WESTWIND SERVICE CENTER NEWSLETTER

December, 1986

Figure 2. Water Separator

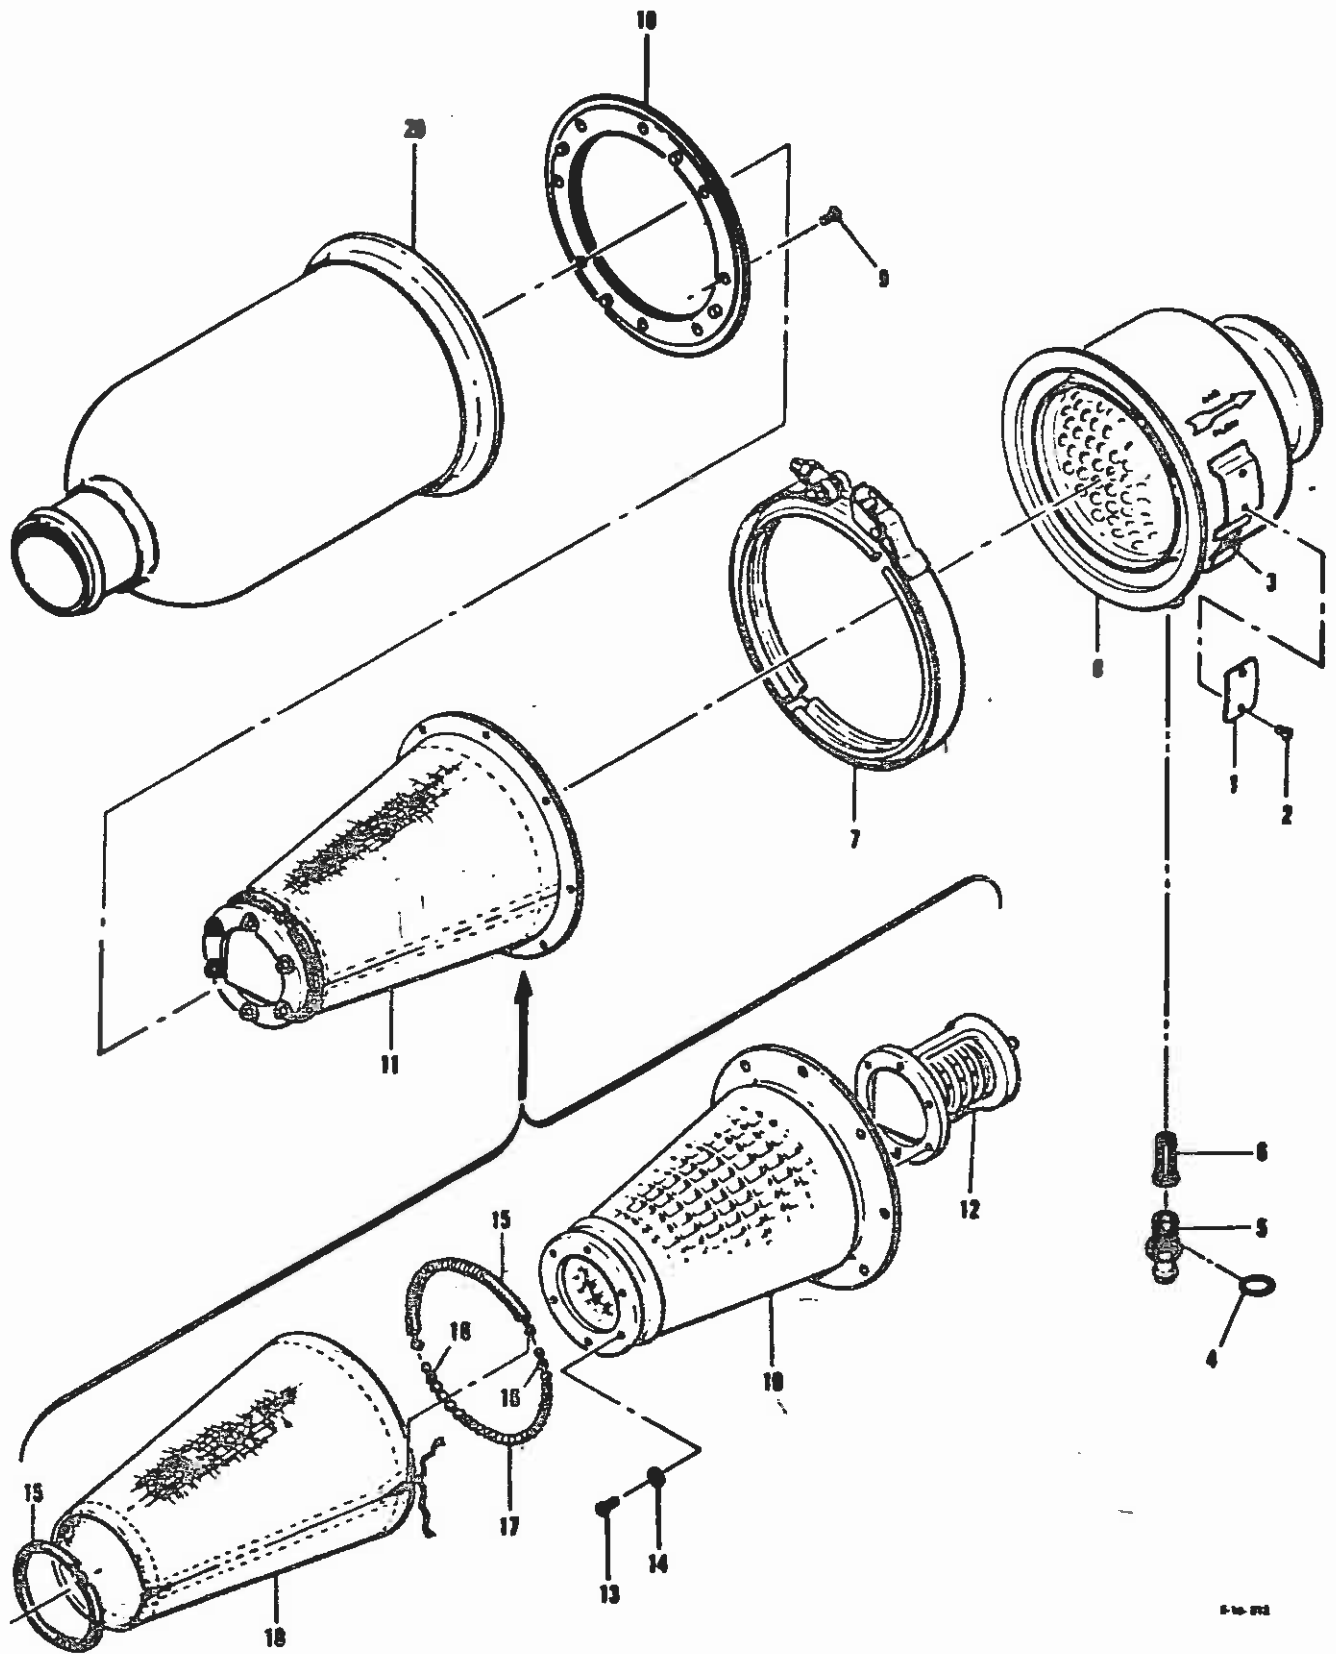
Question: Can I get a parts breakdown of the water separator on the 1124?

Answer: Yes, see the attached pages.

FIGURE 19 . HYDRAULIC LINE AND MAIN RESERVOIR INSTALLATION
(PAGE 3 OF 3)

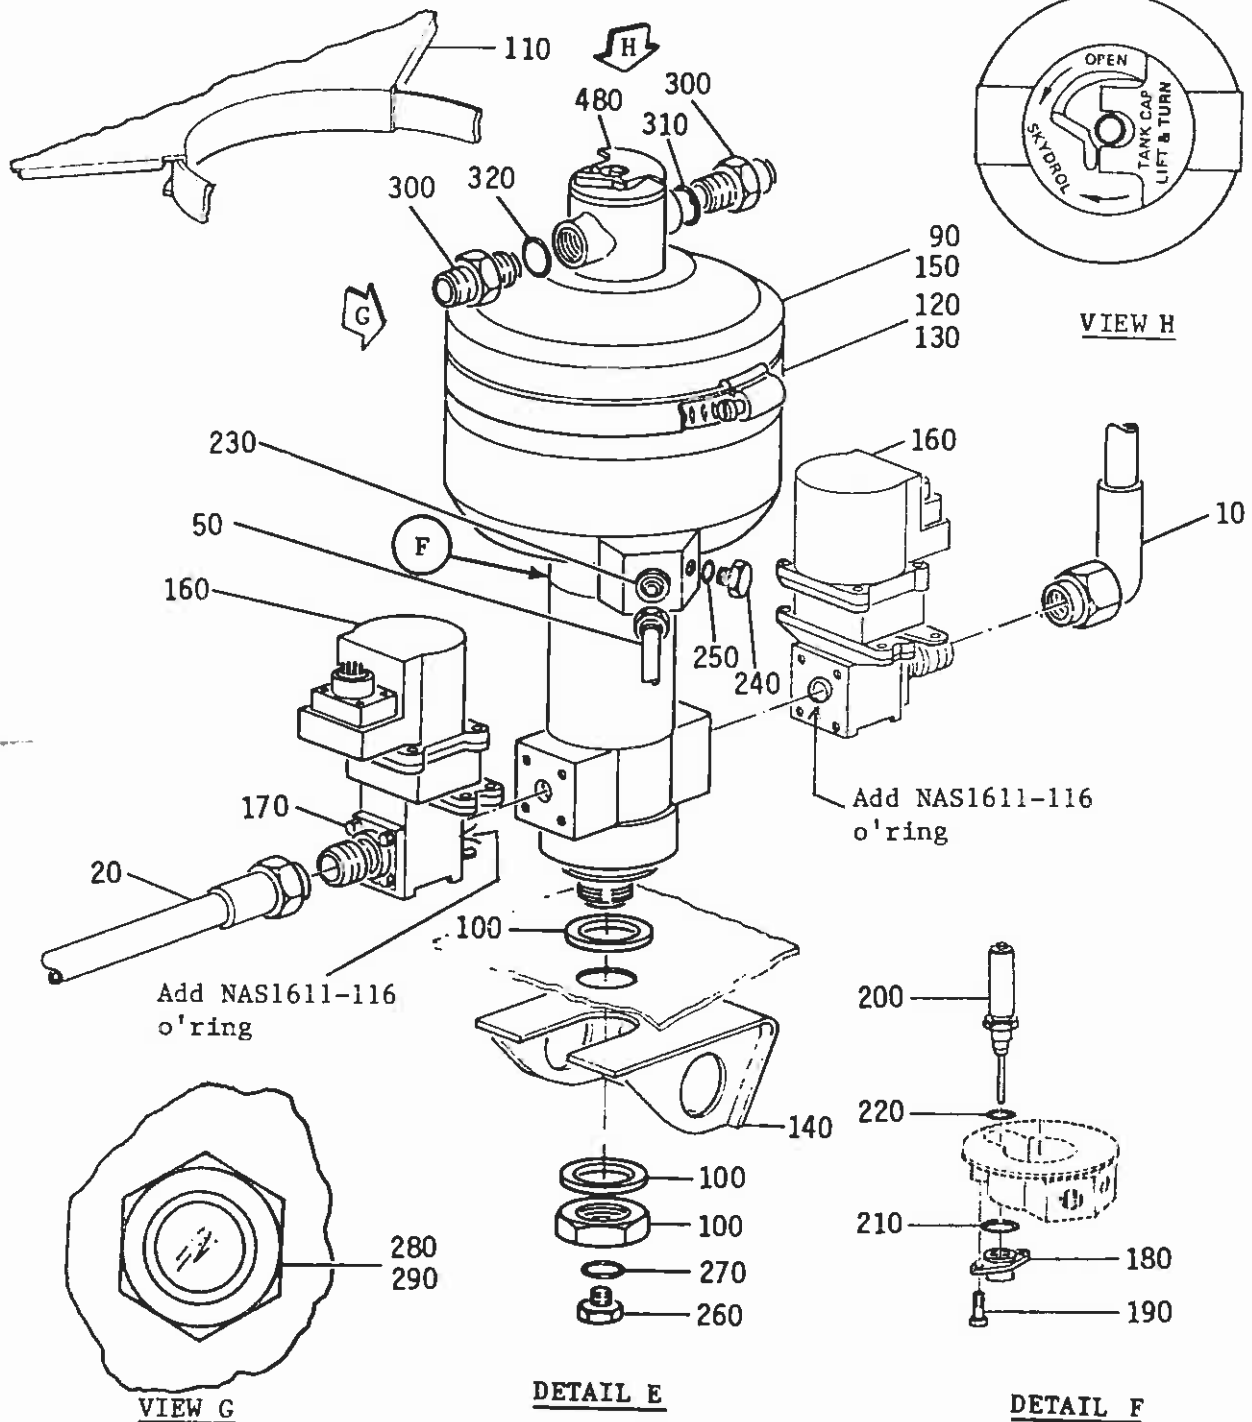
Astra 29-10-00 Figure 19 Page 101

Add a requirement for an o'ring as illustrated on the attachment page.
